COONDEWANNA AIRPORT

PROPOSED AMENDMENT TO APPROACH PROCEDURE AT RUNWAY 08

Figure 1: Current and proposed approach procedure (no changes to lateral tracking are proposed) and nearby mining infrastructure.

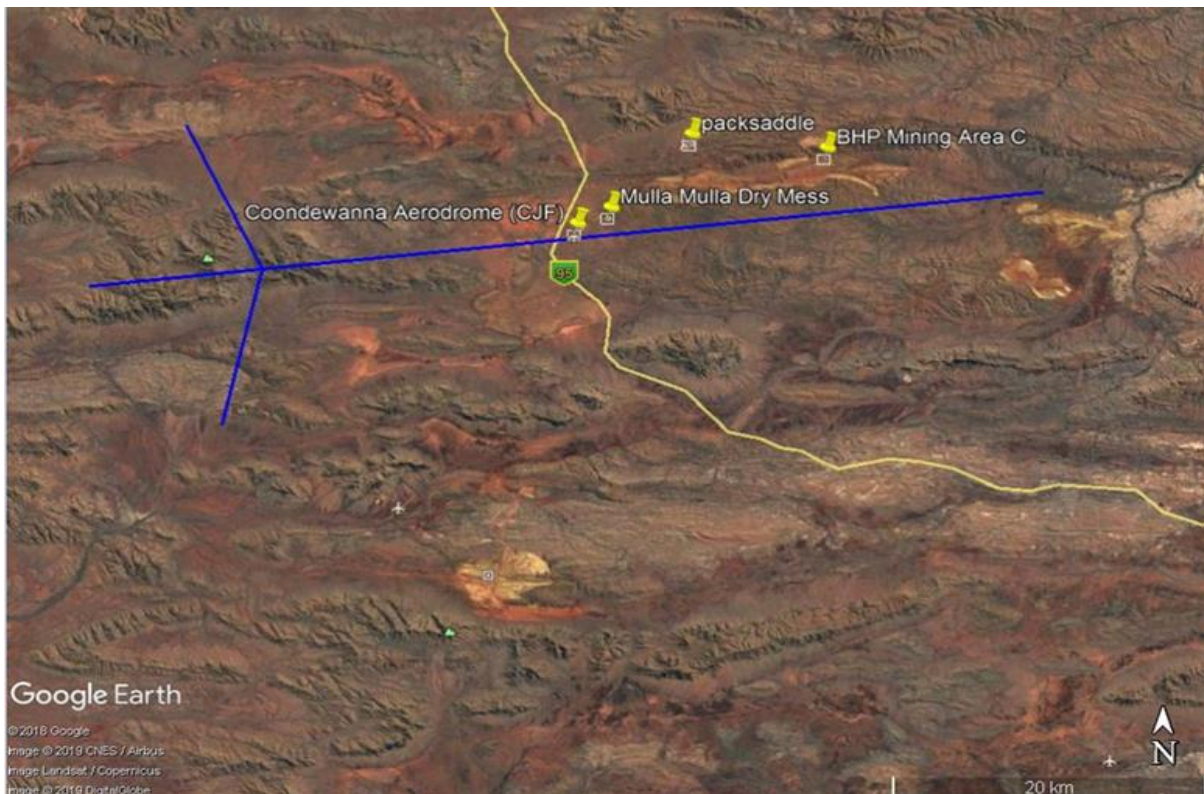
The proposed amendment to the current procedure is a reduction in altitude of approximately 110 feet on approach to the airport (from 3440 feet to 3330 feet). This will provide a safer and more stabilised approach and greater assurance of landing as it will enable increased accuracy on visual approaches.

Aircraft flying the amended current procedure may be observed to be tracking slightly lower closer to the airport due to the reduction in altitude. This will happen within 6-10 kilometres of Runway 08.

There will be no change to lateral tracking of aircraft as a result of this change (**Figure 1** below).
